Section 16 Planning Application for Proposed Minor Relaxation of the Maximum Domestic GFA for the Permitted Residential Development of the Urban Renewal Authority Sai Yee Street/ Flower Market Road Development Scheme ("YTM-013")

**Planning Application No. A/K3/603
-Submission of Response-to-Departmental Comments-**

Responses to Departmental Comments Table

Drawing Title			
PROPOSED WIDENING OF SIGNALISED CROSSINGS			
Designed	HMC	Checked	CYH
Scale	1:500(A3)	Date	AUG 2026
Drawing No.	5.1	Rev.	A

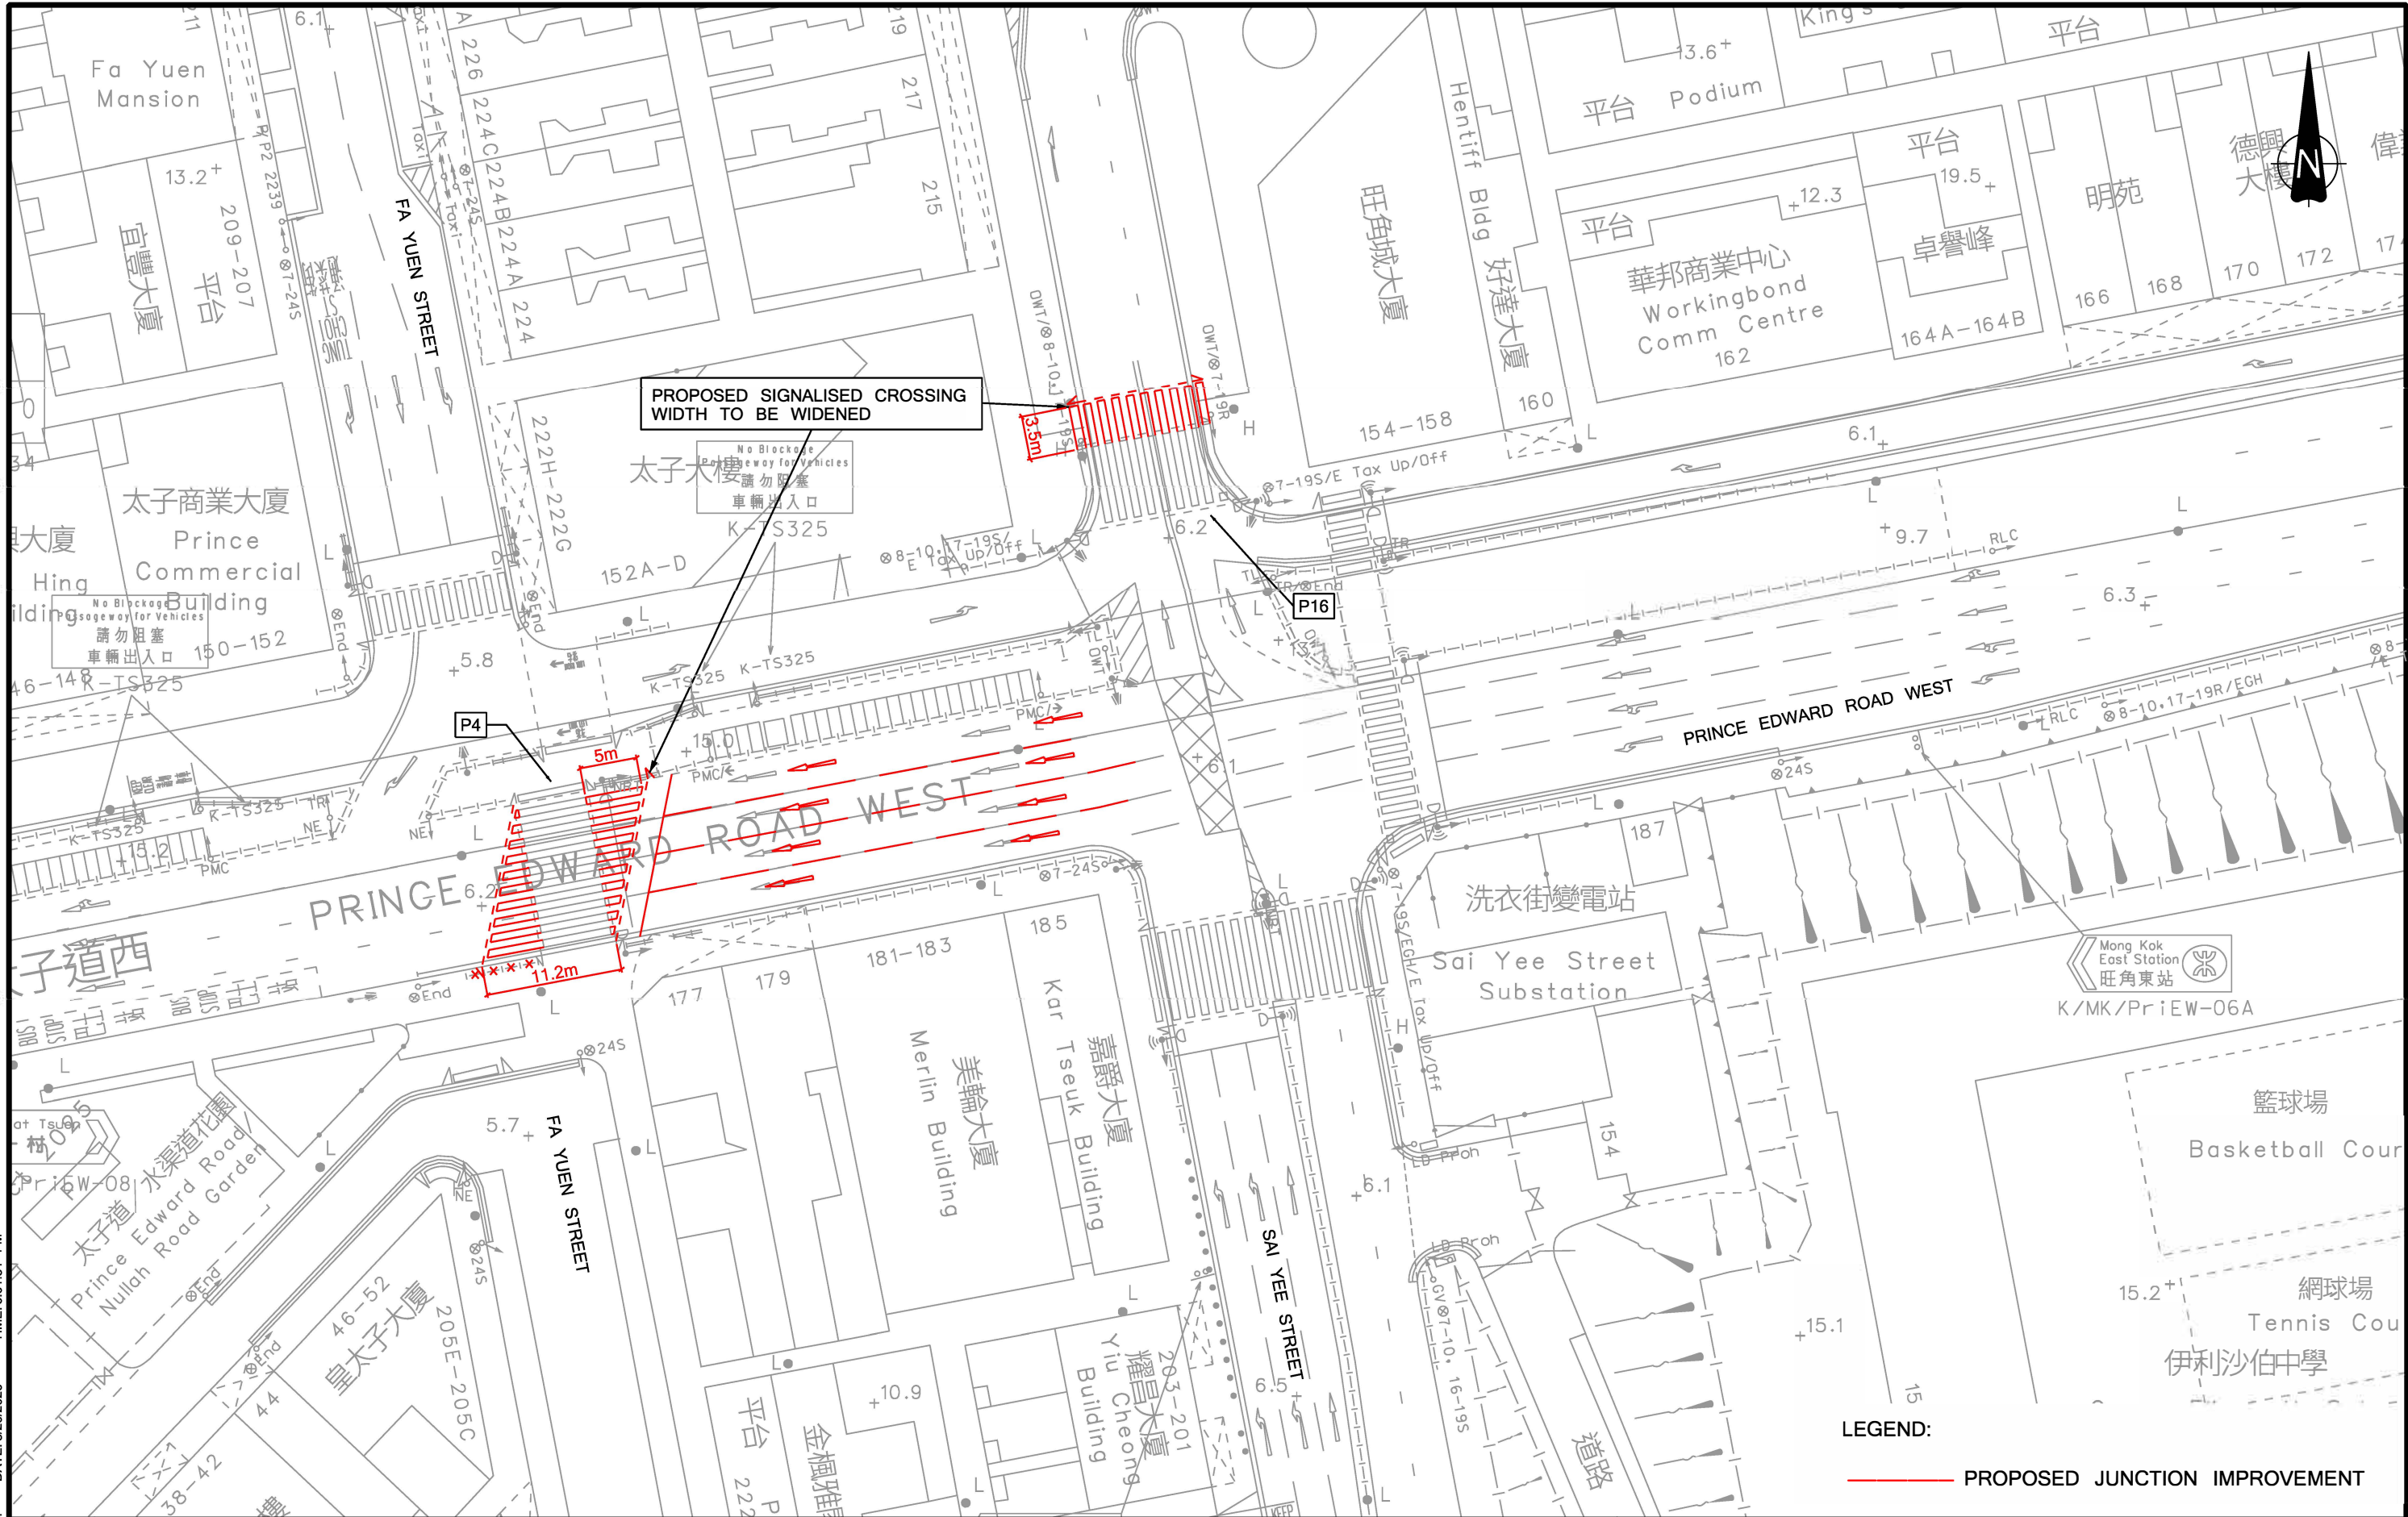
Departmental Comments	Responses
1. Comments from Commissioner of Police (CP)	
<i>Received via email dated 7 Aug 2026</i>	
Widening of Pedestrian Crossings (a) Chapter 5 of the Traffic Impact Assessment (TIA) indicates that the signalized crossings across Prince Edward Road West / Fa Yuen Street (P4) and Sai Yee Street near Prince Edward Road West (P16) are already overloaded during existing weekend peak hours. With the additional foot traffic generated by the proposed development, further congestion at these crossings is expected. Overcrowding at these key crossings will cause pedestrian queues to spill off the footpaths and onto active traffic lanes. This creates a severe risk of traffic accidents and will demand continuous and substantial police manpower deployment for crowd and traffic control. The proposed physical widening of signalized crossings (i.e. P4 and P16) should therefore be mandatory.	Noted. The two proposed signalized crossings were already proposed in the TIA at the DSP planning stage to address the local traffic conditions. It is not resulted from the current S.16 planning application. Upon implementation of the approved DSP, URA will implement the proposed physical widening of signalized crossings (P4 and P16), subject to technical feasibility and agreement with relevant Government departments. The detailed design, layout, implementation programme of the proposed widening will be further developed in the implementation stage in consultation with TD, HKPF and other relevant Government departments as appropriate.
